**RE: Addendum No. 1**

**PROJECT: Request for Bid – Health Sciences 226 & 236 Rehabilitation**  
**HVAC Replacement, RFB 2425-1**

**DATE OF ADDENDUM ISSUE: February 26, 2025**

**100% CONSTRUCTION DOCUMENTS**  
**ISSUE DATE:**  
**05.18.2024**  
**SHEET NUMBER:**  
**M101**  
**SECOND FLOOR HVAC PLAN**

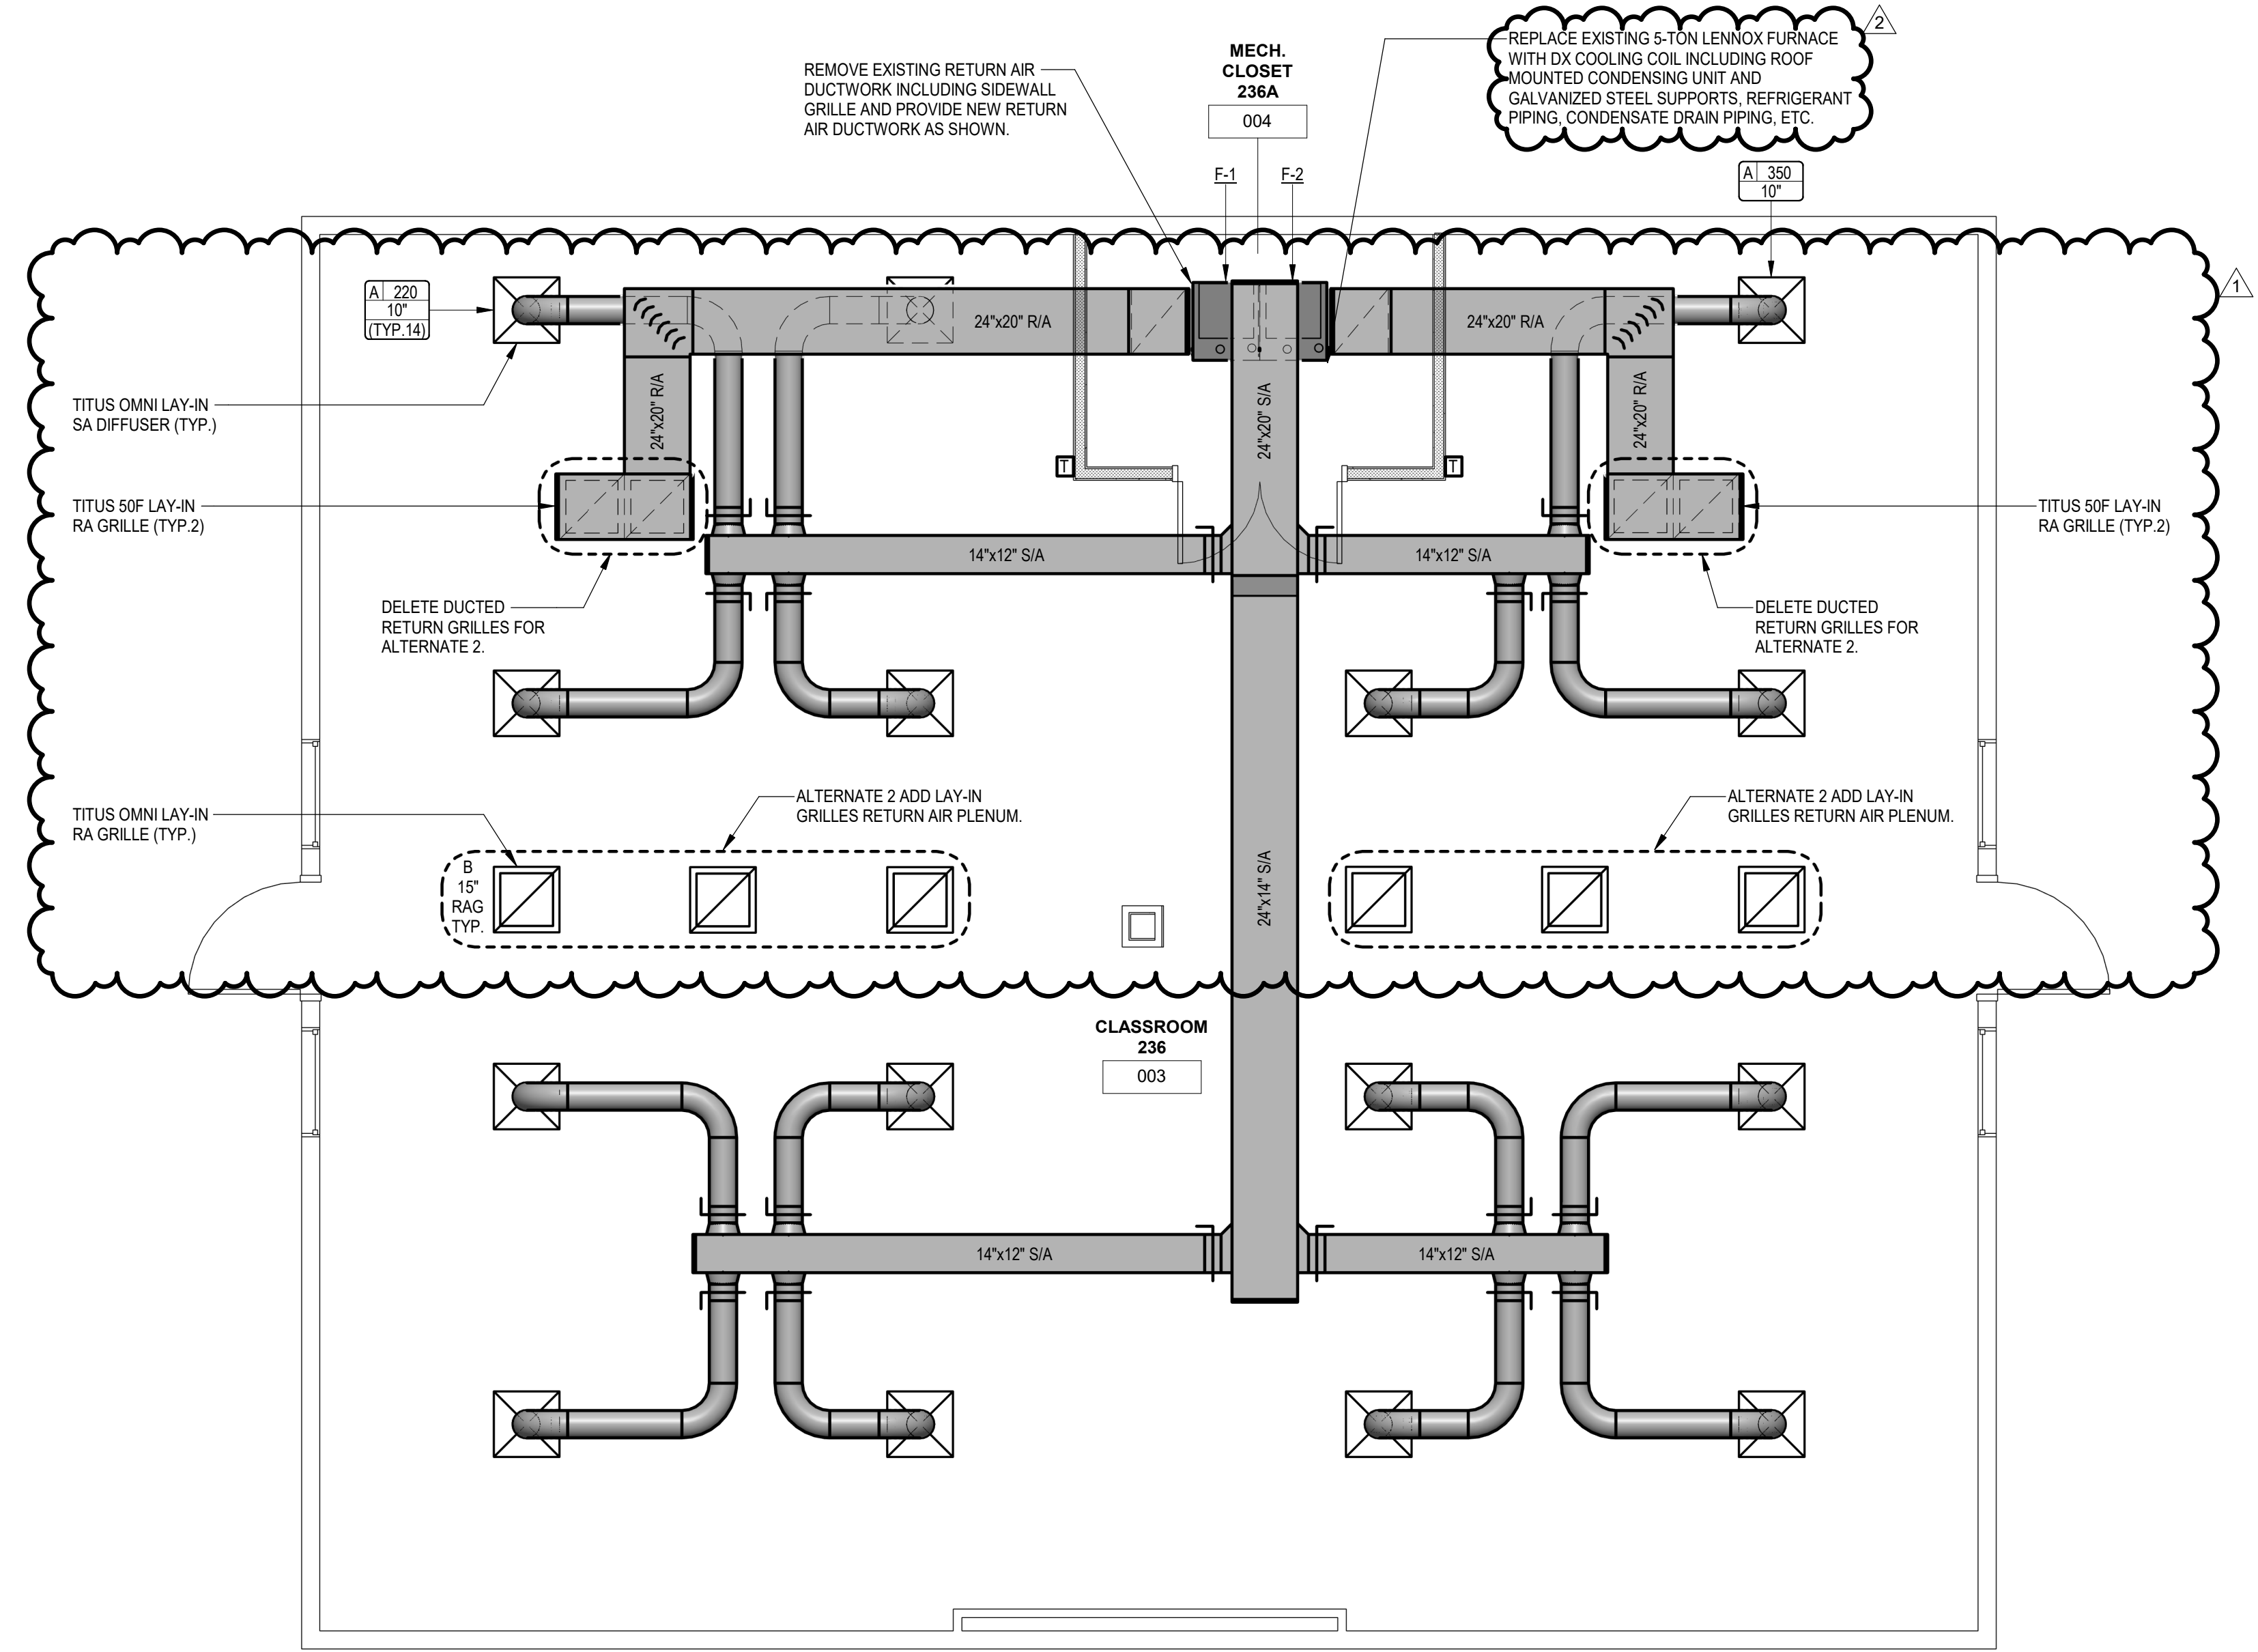
**Item No. 5 – See attached sheets M001, M002, M101, E101 for associated Clarifications, Additions, and/or Changes.**

**100% CONSTRUCTION DOCUMENTS**  
ISSUE DATE:  
**05.18.2024**  
SHEET NUMBER:  
**E101**  
LIGHTING AND POWER PLANS

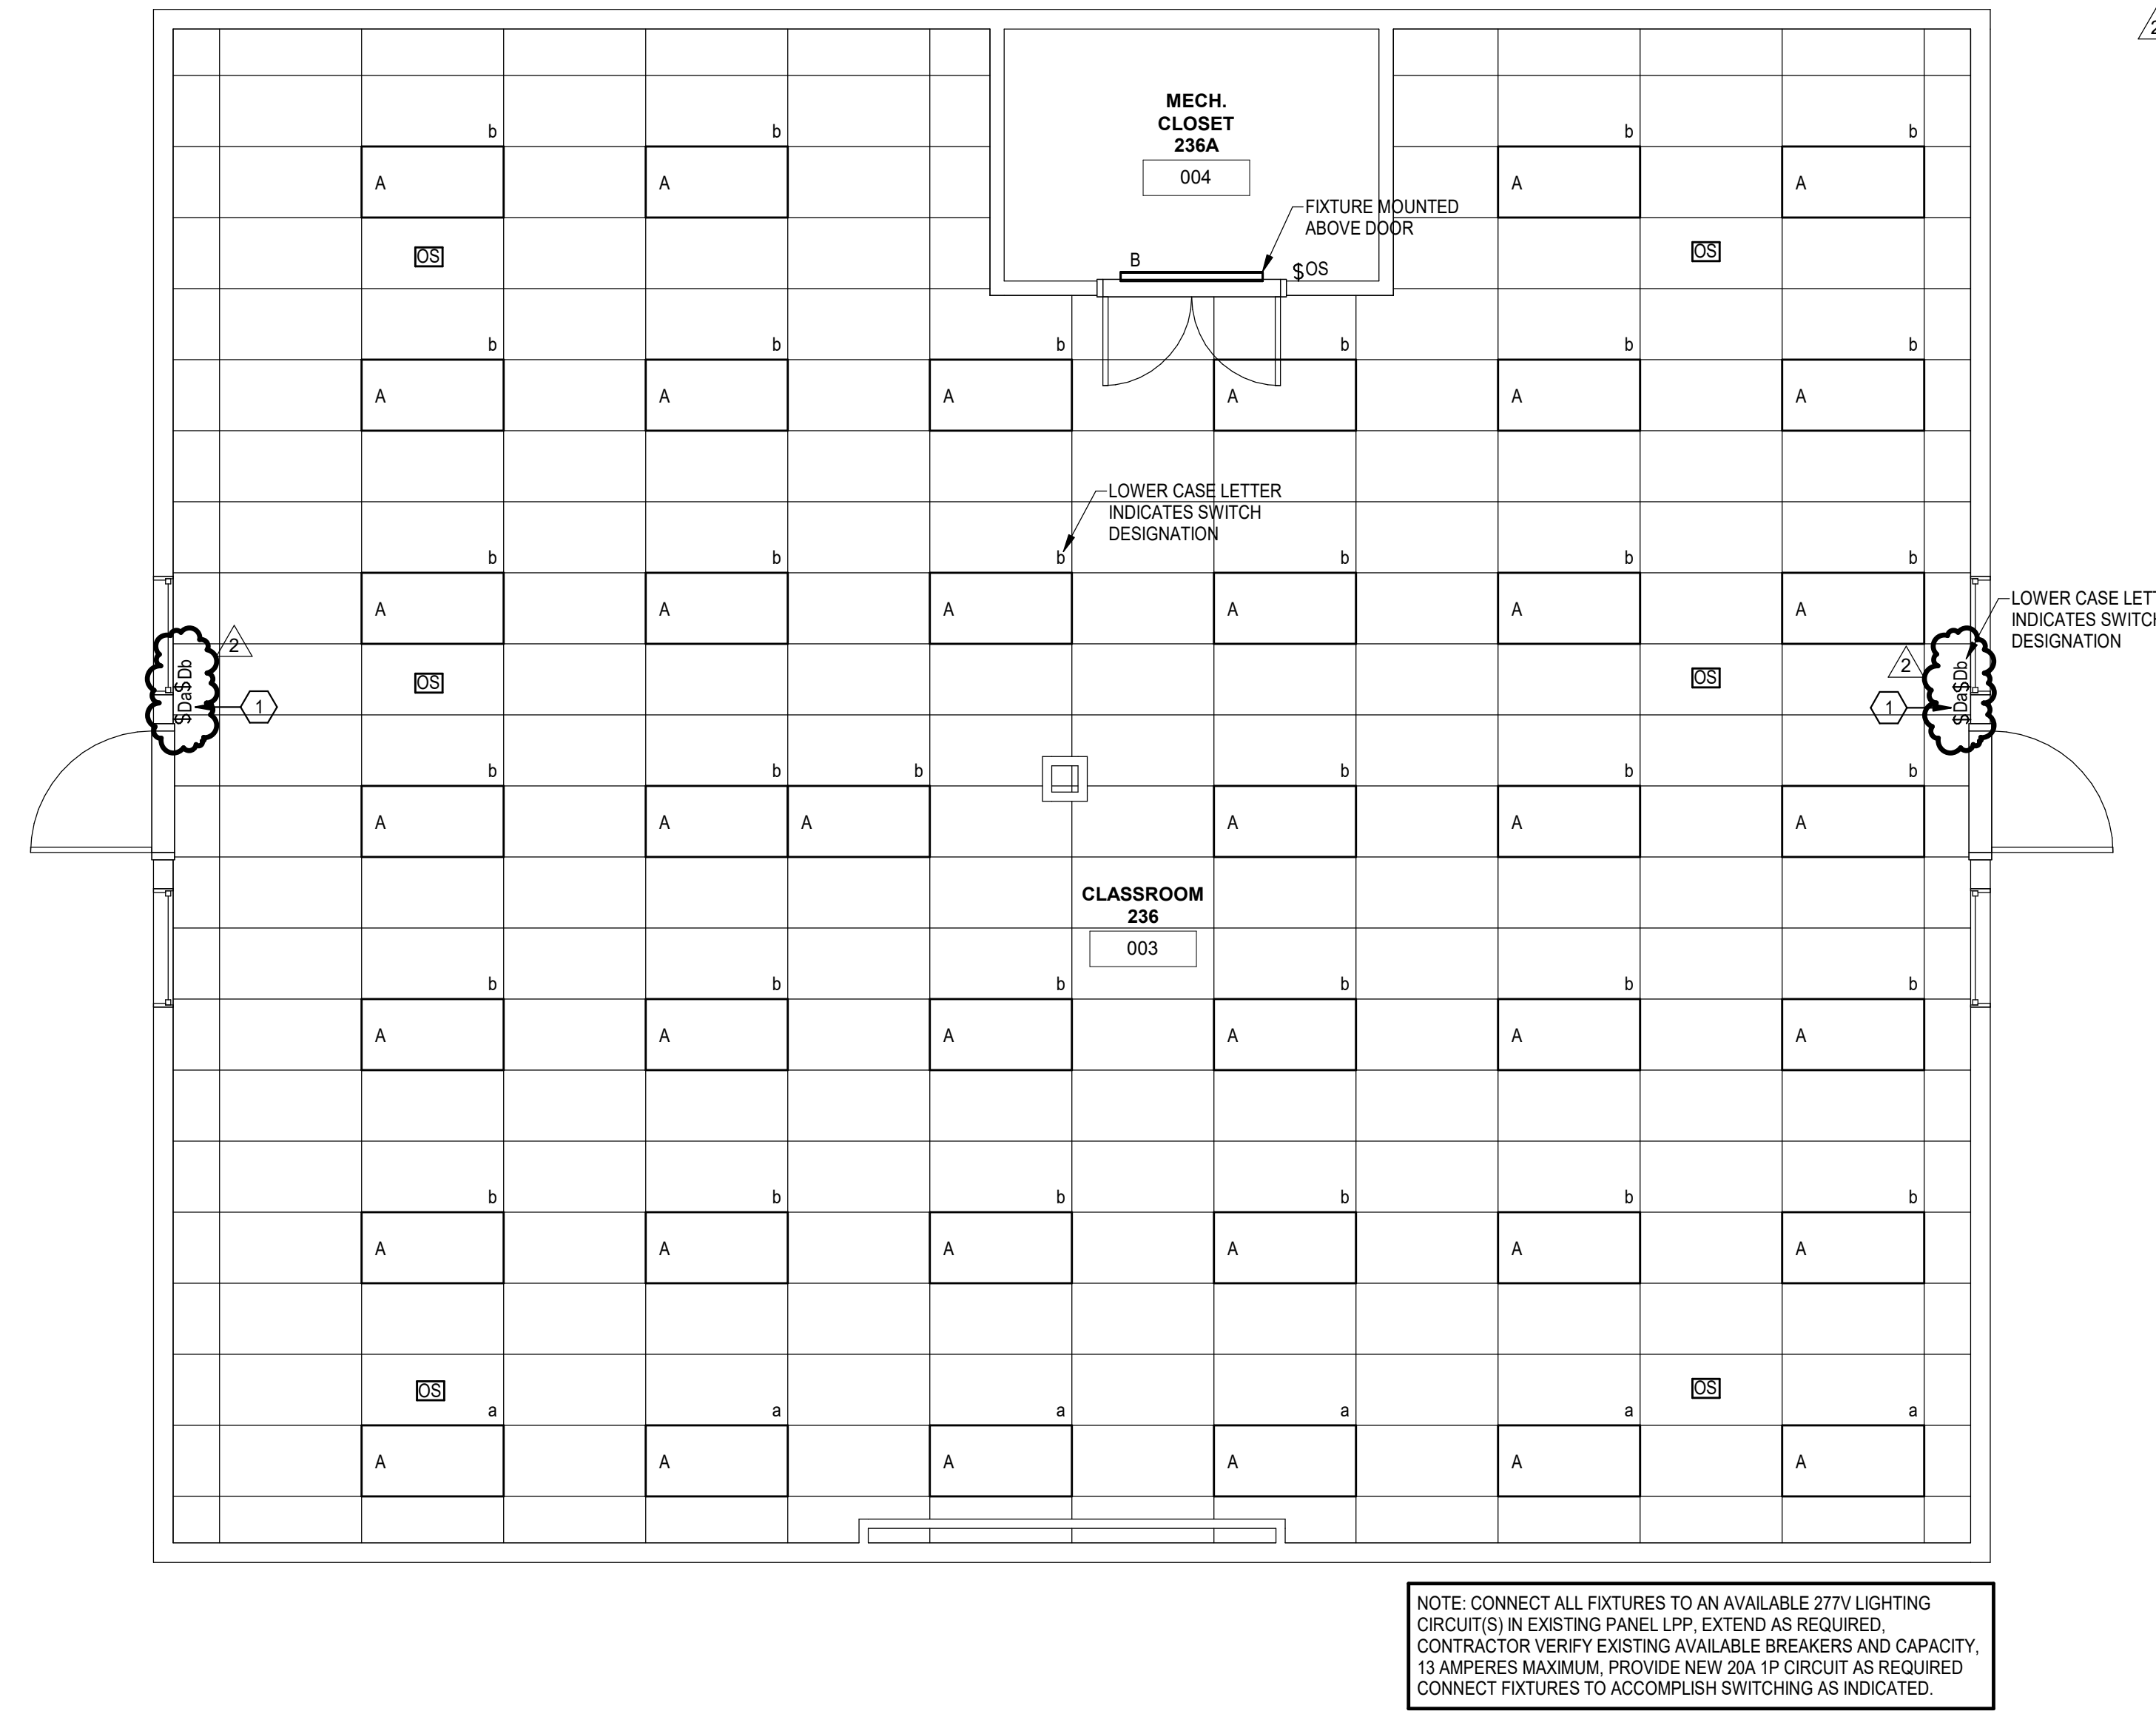
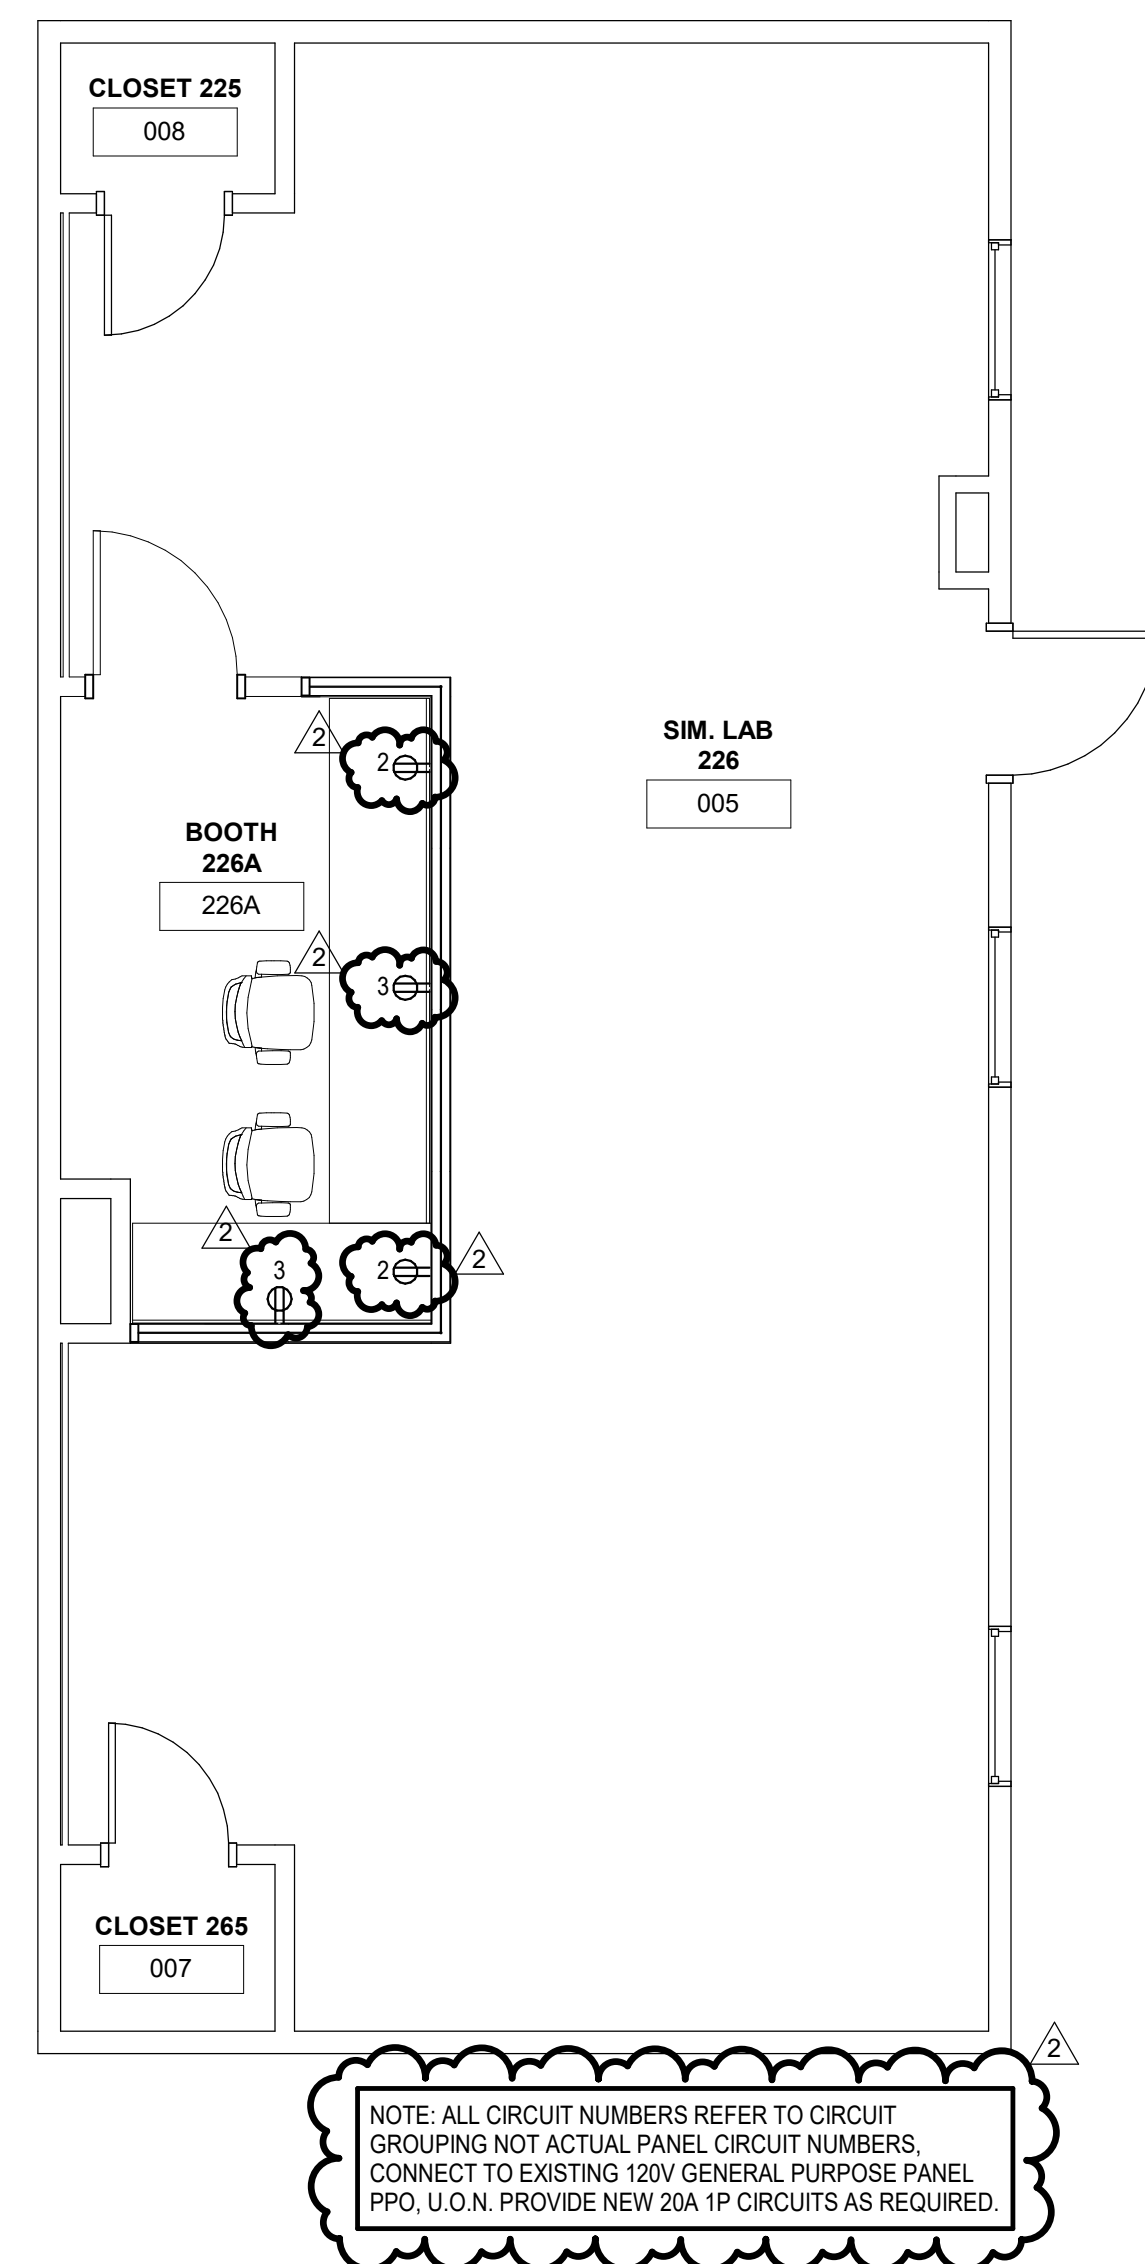
**Item NO. 9 – Question -- Are we adding and new receptacles to level 2? it's not clear what is ETR and what is new.**  
**Answer - Yes. New and ETR receptacles clarified in Addendum 1**

**Item No 11 – Question - Is any of the roof work in our scope?**  
**Answer - Yes, the existing roof mounted condensing unit is being replaced. Refer to Addendum 1 for electrical scope.**

**Item No. 2 – Contractor to provide and install in room 236, lighting dimmer controls for the new lighting system, per the drawings.**
